METROPOLITAN GOVERNMENT OF NASHVILLE AND DAVIDSON COUNTY

STAFF RECOMMENDATION
Ransom Avenue/Byron Close Development
104, 112, and 117 Ransom Avenue
March 18, 2015

Application: New construction--infill
District: Elmington Place Neighborhood Conservation Zoning Overlay
Council District: 25
Map and Parcel Numbers: 104100O00500CO, 104100O00700CO, 104100O00900CO
Applicant: Barlow Builders
Project Lead: Melissa Baldock, melissa.baldock@nashville.gov

SITE PLAN
 OF
LOT 5, BYRON CLOSE SUBDIVISION
 PLAT DOC #20131018-0108864
 NASHVILLE, DAVIDSON COUNTY, TN.

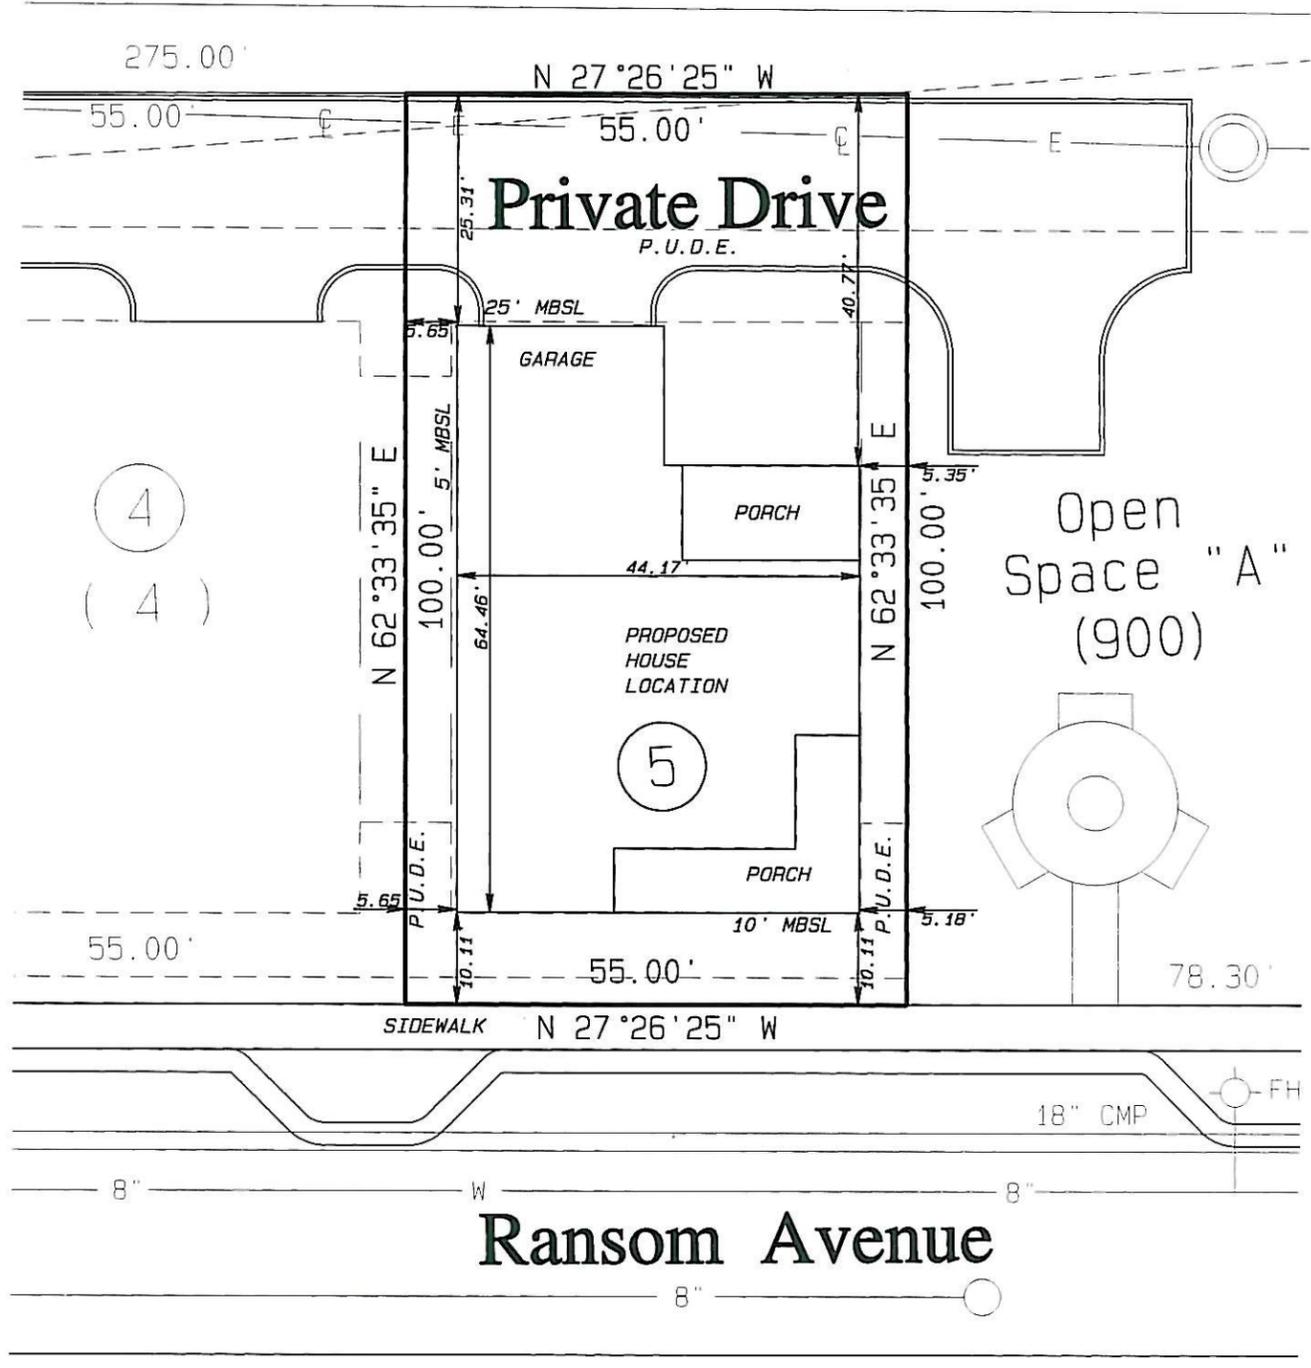
Lot 5’s primary cladding material will be lap siding, and staff asks that the siding exposure be five inches (5”) or less. The foundation material will be brick, and staff asks to approve a brick sample. Lot 5 has a bay area clad in brick on the right side elevation (which is visible from Richardson Avenue). In this section there is no differentiation of material from the foundation to the wall above, and staff asks that there be a differentiation in material.

Lot 5’s side elevations show a dormer that was previously part of the front elevation, but which has since been removed. Staff asks that the side elevation drawings be corrected and the dormers eliminated. With this condition, Staff finds the projects meets section II.B.1.e. of the design guidelines.

LOT 9 BYRON CLOSE

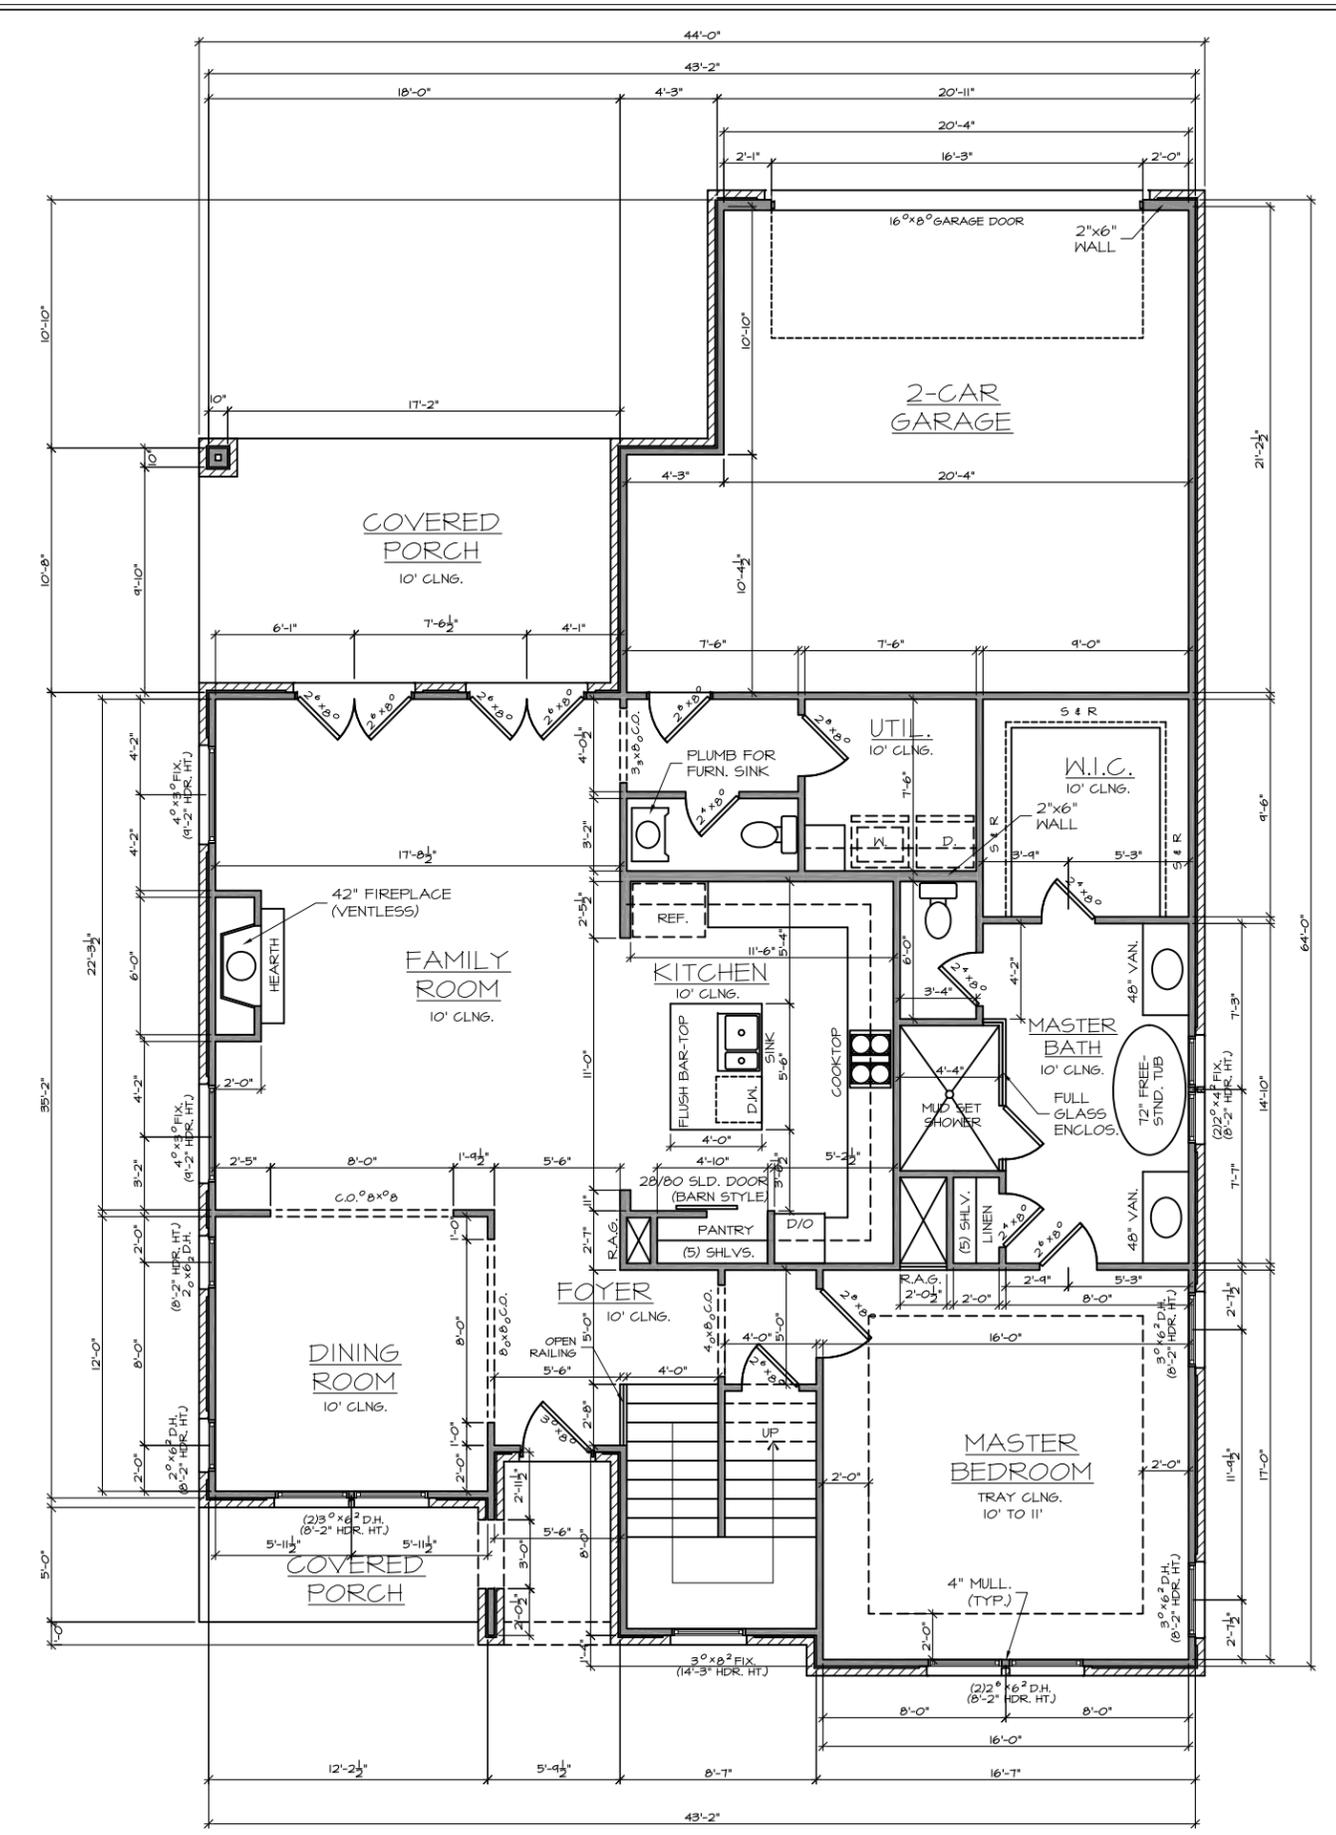
Staff finds that most of these measurements are similar to what have been approved by the Commission in the past for the Ransom/Byron Close development, and they meet the historic context. The one exception is the height for Lot 9. Staff asks that the height be reduced so that it is no more than thirty-five feet (35'). The majority of the historic homes in the immediate vicinity are one to one-and-a-half-stories, although there are several two-story homes in the conservation overlay. The historic two-story homes range from twenty-eight feet (28') to thirty-five feet (35') in height, and the Commission in the past has asked for the houses in the Ransom Avenue development to be no more than thirty-five feet (35') tall.
